STAFF REPORT
COMMUNITY DEVELOPMENT DEPARTMENT

HEARING DATE: May 3, 2022
TO: Mayor & City Council
FROM: Joseph Dodson, Associate Planner
208-884-5533
SUBJECT: H-2022-0005
Summertown Subdivision

Preliminary Plat consisting of 23 residential building lots (9 single-family lots and 14 multi-family lots) and 3 common lots on approximately 13.8 acres of land in the TN-R zoning district (Traditional Neighborhood Residential), by Summertown, LLC.

B. Preliminary Plat (dated: January 2022)

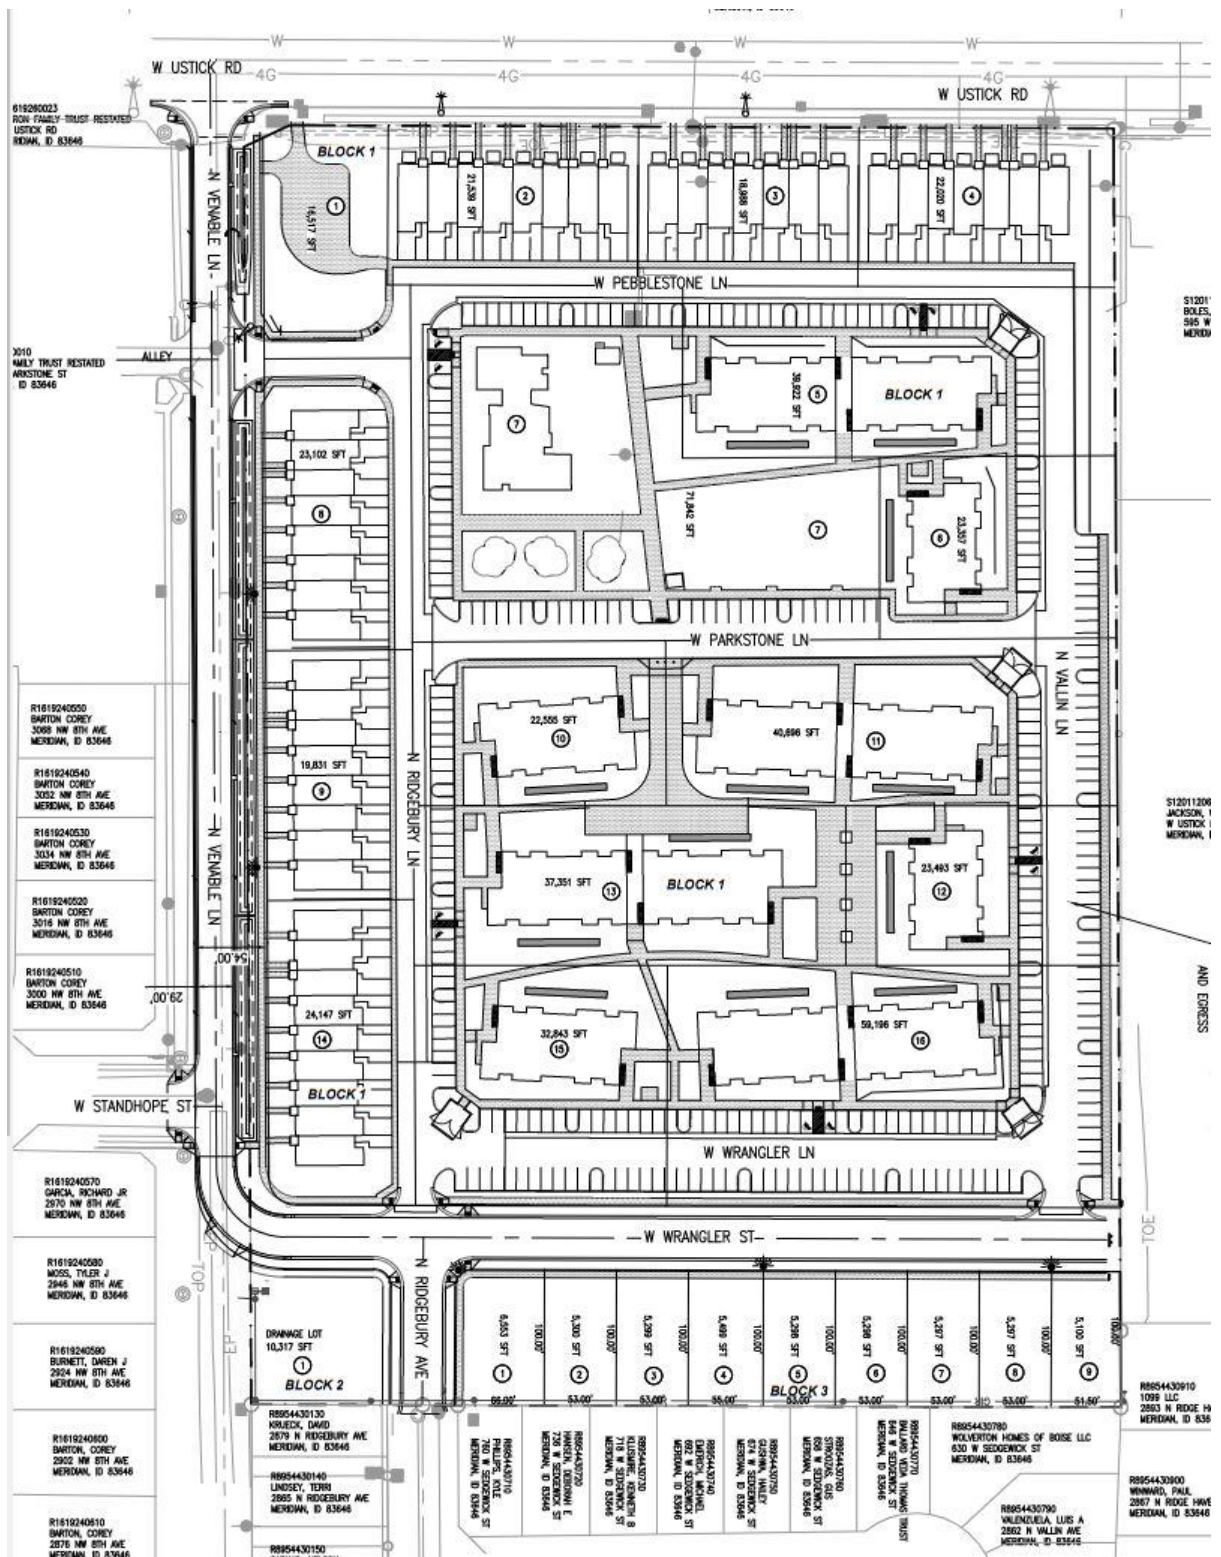
Upon analysis of the submitted plat, it appears N. Venable Lane is being shown as a 29-foot collector street section for its entire length, from Ustick south to Wrangler Street connection point at the southwest corner of the project. Previous approvals allow Venable to be constructed with this reduced collector street section for a majority of its length but not in its entirety. According to ACHD, Venable should be constructed as 36-foot wide collector street section from Ustick and 245 feet south to the northern drive aisle connection across from the existing drive aisle connection to Venable for the Crossfield Apartments. It is unclear on the submitted plat if this condition of approval is being shown accurately. The Applicant should revise the plat to meet this condition of approval or provide written documentation that ACHD has approved a reduced street section for this area of the project.

Staff finds the previously approved project complies with the private street applicability standards as it is not a single-family development and all of the units front on or access green space rather than the street. Further, the drive aisles (private streets) are shown to be 26 feet wide with sidewalks adjacent to a majority of the parking stalls. UDC 11-3F-4 requires private streets to be a minimum of 24 feet wide and sidewalks are not required. Therefore, the Applicant complies with the minimum dimensional standards outlined in the UDC. In addition, the private street must be within a single platted common lot or constructed on a perpetual ingress/egress easement. According to the submitted plat, the private street is not within a common lot and is noted as being within an easement. However, this easement is not clearly depicted on the plat and a plat note has not been included noting its purpose. These items should be corrected with the final plat submittal. If these conditions of approval are met, Staff finds the

*In addition to the 5-foot detached sidewalk along Venable, the Applicant is showing 4-foot wide sidewalk on the west side of the internal private street that runs north-south within the multi-family portion of the project (shown as N. Ridgebury Lane). Ridgebury Lane is shown with sidewalks on both sides of the private street but is not required by code, as noted in the previous section. In addition, the Applicant has some room within the building lot itself to adjust the property line and building setback to Venable because the TN-R zoning district allows a reduced setback when the units are alley-loaded—these multi-family units take vehicular access via Ridgebury Lane, an alley in its functionality, and main pedestrian access along Venable. **During pre-application meetings, Staff presented this issue and recommended the Applicant remove the western sidewalk along Ridgebury Lane and make minor building lot adjustments to construct the required multi-use pathway along the east side of Venable. Per the submitted plat, the Applicant did not make these revisions. In order to comply with the Pathways Master Plan, Staff is including conditions of approval consistent with these recommendations.***

*Furthermore, this multi-use pathway segment is shown to continue south through an adjacent County parcel (S1201214713) in the future. In order to allow for this to occur, a logical termination of the multi-use segment on the east side of Venable should occur so that a safe crossing location is attainable. The logical location for this would be at the northeast corner of Venable and Wrangler Street so it can be constructed at the southwest corner of this intersection should the county parcel redevelop in the future. Staff notes, the existing county residence takes access via Venable and will continue to do so until such time the property redevelops. After reviewing the existing conditions of the county parcel and the existing stub streets to its property, Staff anticipates this existing access being removed and becoming an area of open space and the multi-use pathway segment. Therefore, setting up the correct locations of the multi-use pathway stubs with this project to the county parcel is significantly important. Staff **recommends the Applicant** construct a segment of the City's multi-use pathway within Lot 1, Block 2.*

11. The submitted preliminary plat, dated January 2022, shall be revised as follows prior to Final Plat submittal:
 - a. Depict the required landscape buffers along Ustick and Venable via a landscape easement—ensure minimum width of 25 feet along Ustick is noted despite not being on property (measured from back of curb).

- b. Add a plat note referencing the required license agreement with ACHD for the portion of the landscape buffer in the public right-of-way, per UDC 11-3B-7C.5.b.

- c. Construct a 10-foot wide multi-use pathway on the east side of N. Venable Lane. ~~and within Lot 1, Block 2 consistent with the Pathways Master Plan.~~

- d. Remove the sidewalk on the west side of N. Ridgebury Lane (east side of Lots 8, 9, & 14, Block 1) to move the units east to accommodate the multi-use pathway on the east side of N. Venable.

- e. Depict the private streets within a singular common lot or clearly depict the private street easement on the plat, in accord with UDC 11-3F-4A.
 - f. Add a plat note stating “No direct lot access is permitted to W. Ustick Road or N. Venable Lane.”
12. The submitted landscape plan, dated December 27, 2021, shall be revised prior to final plat submittal:
- a. Revise the landscape plans consistent with the preliminary plat revisions noted above in condition VIII.A.8.
 - b. Add data to the landscape plans showing compliance with UDC 11-3B-7C for the proposed parkways.
 - c. Clearly depict the required street buffers along W. Ustick Road and N. Venable Lane.

C. Landscape Plan (date: 12/27/2021)

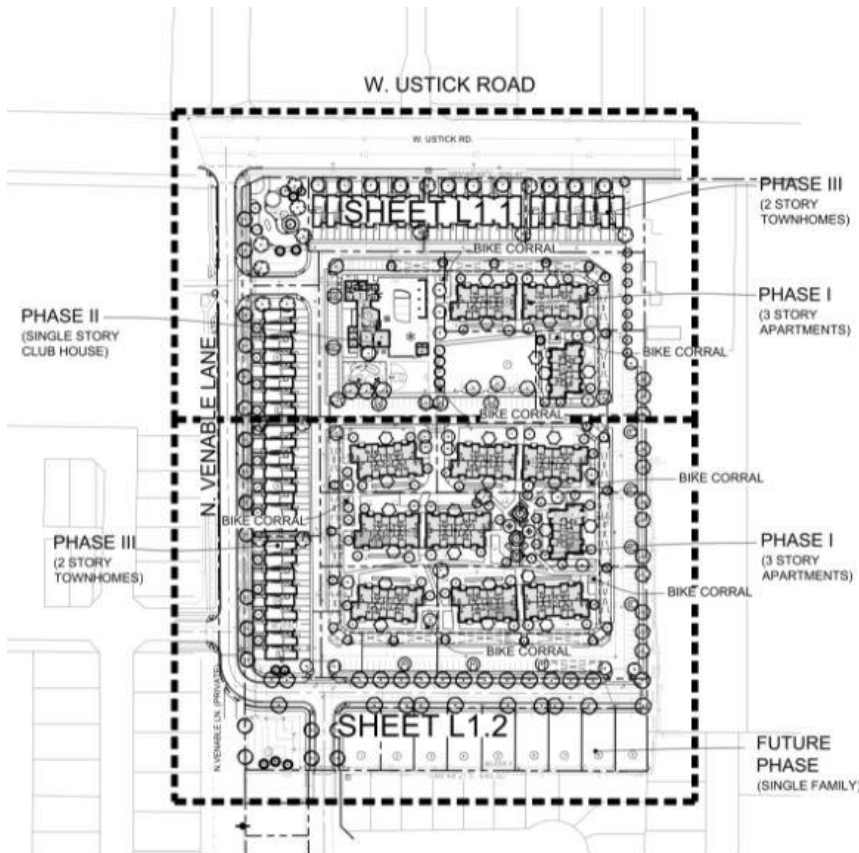
8-foot wide parkways with street trees are shown along both sides of the proposed local streets (W. Wrangler and N. Ridgebury). **All parkways within the site adjacent to detached sidewalks shall be landscaped per the standards listed in UDC 11-3B-7C.** According to the submitted landscape plan, there appears to be the correct number of trees but the table does not accurately describe the parkway along W. Wrangler and instead labels it as perimeter landscaping. With the future final plat application,

the Applicant should correct this and list this parkway within the landscape table and show the correct number trees.

Staff notes the existing approvals do not account for the parkways along W. Wrangler and the Ridgebury Avenue stub. So, the amount of qualified open space is in fact higher than previously noted—with the final plat submittal, the applicant should revise the open space calculations and include these parkways.

7. With the final plat submittal, the applicant shall submit a revised open space exhibit that includes the parkways as part of the open space calculations.
